MILITARY SPECIFICATION

BEARING, BALL, ANNULAR, ANTIFRICTION,
ACCESSORY, HIGH SPEED, TURBINE, AIRCRAFT

This amendment forms a part of Military Specification MIL-B-83175, dated 1 May 1969, and is approved for use by all Departments and Agencies of the Department of Defense.

MIL-B-83175
AMENDMENT 1

"6.2.1 Example of part number:

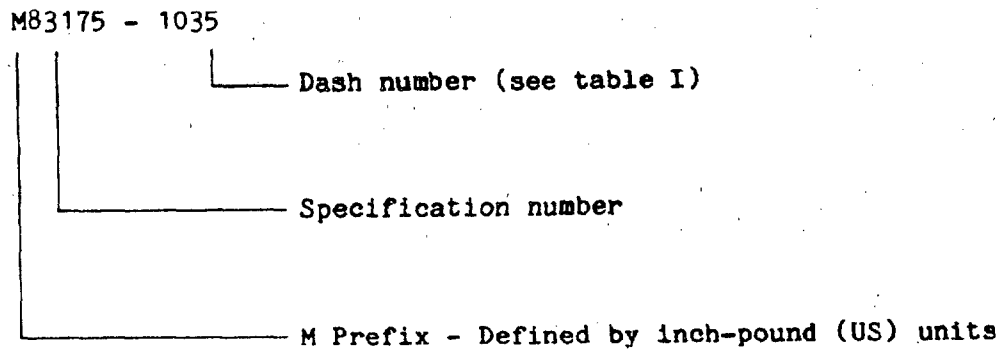
6.2.1: Add new paragraph:
